McDONALD'S

MC DONALDS - SITE PLAN
RT. 32 (HO THU YSEN) (SCHOLZ)

**PLANNING BOARD WORK SESSION
RECORD OF APPEARANCE**

SITE PLAN

SP-1

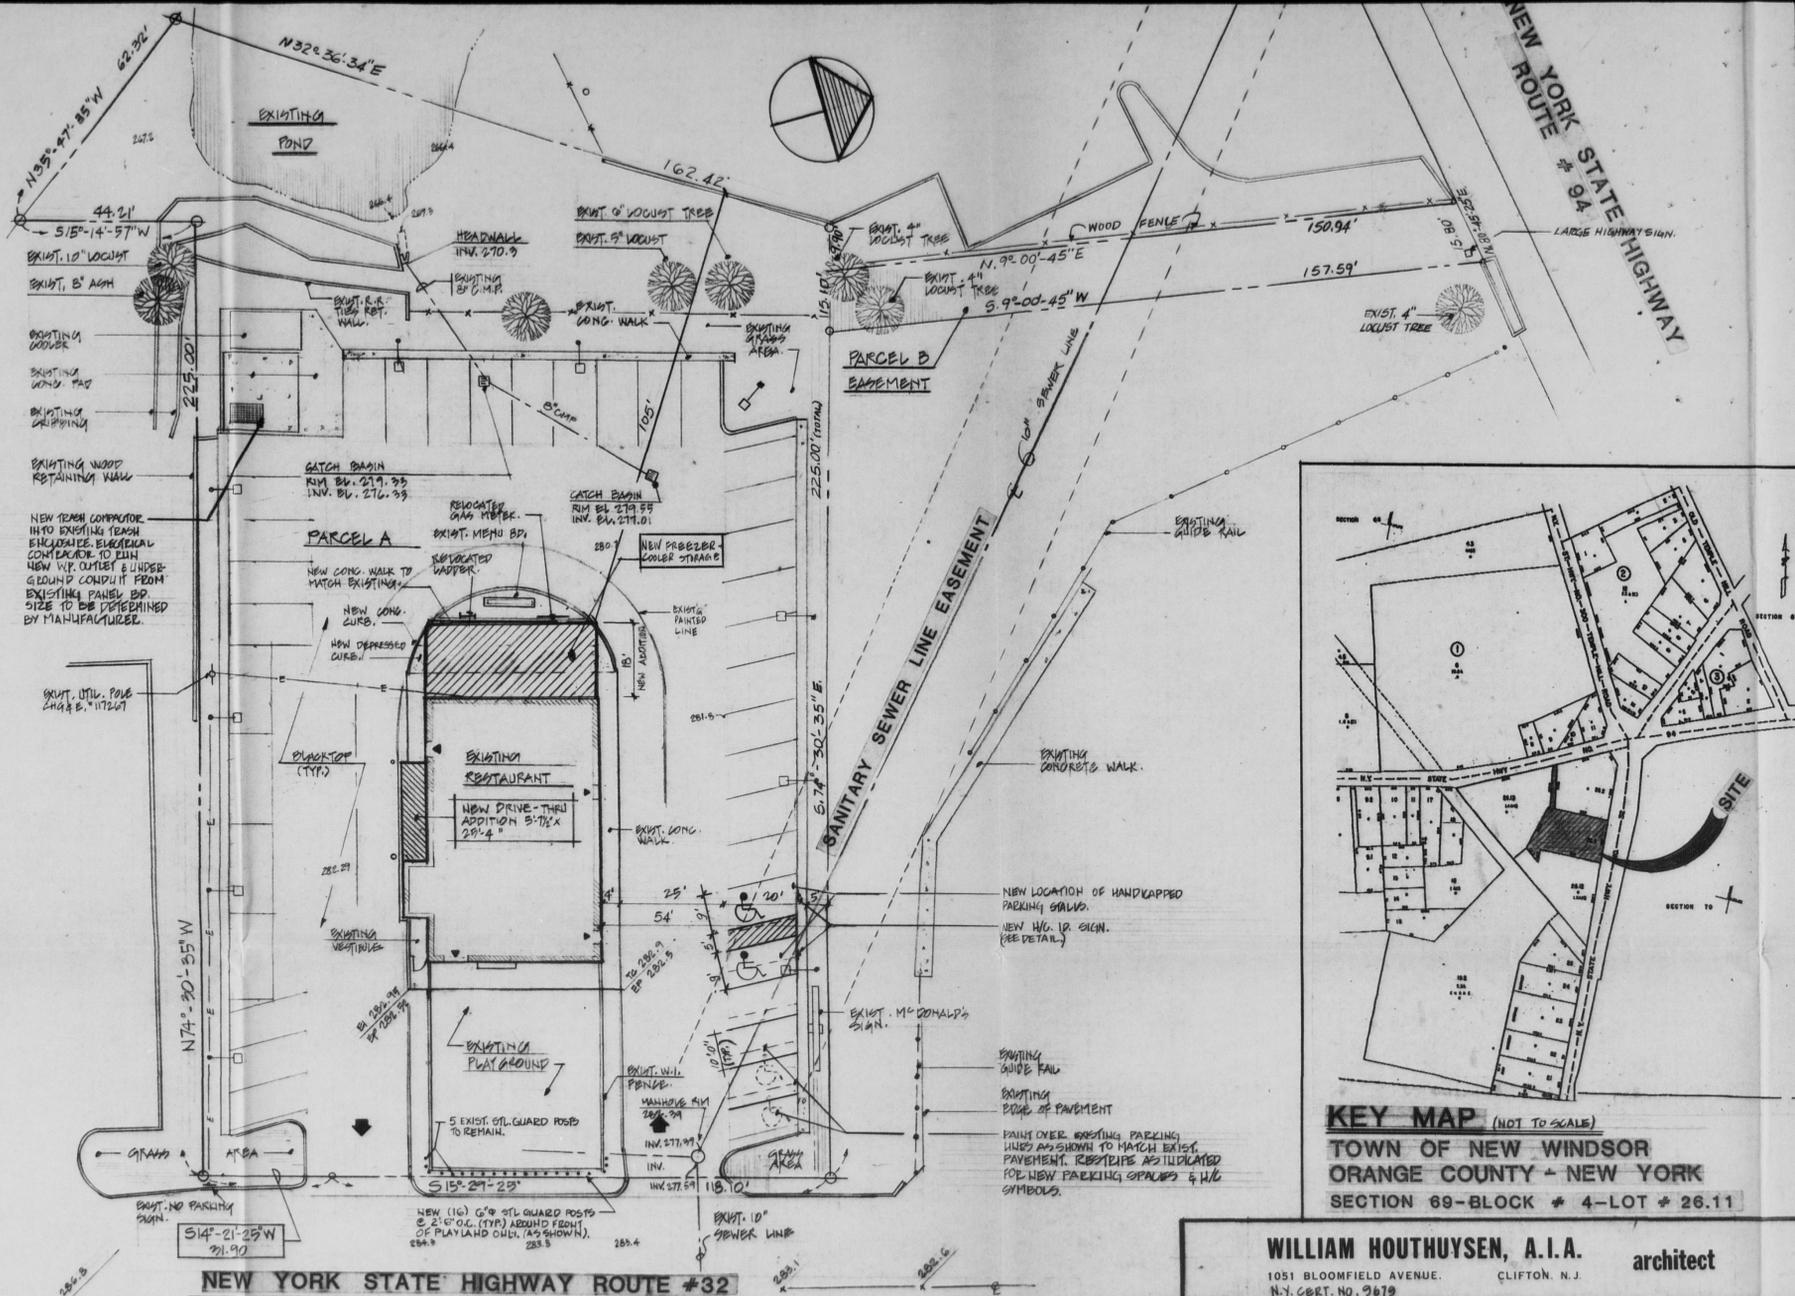
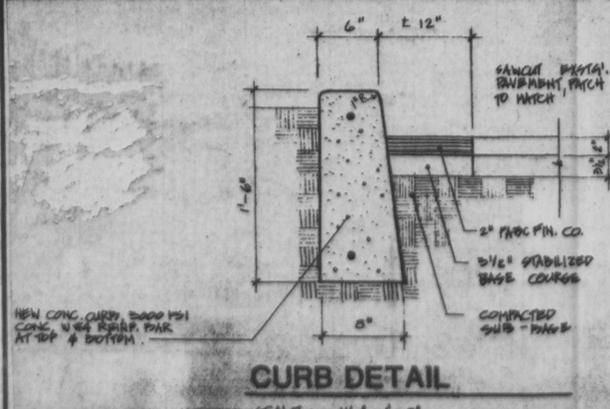
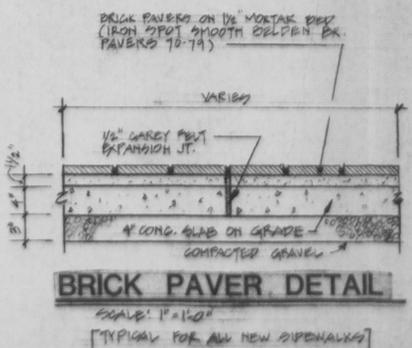
move Dr; correct signs.

add compactors -

seating from, to.

ADDITIONAL COMMENTS: Present Drive on Route 24 is authorized, McDonald's notified that at time of Veil Gate Re construction

Very truly yours, This Driveway would be closed off by State. McDonald does not own enough frontage to construct an access at this location.

~~If disapproved, please list reason~~
water line had been marked out - Call
water dept. before excavation -
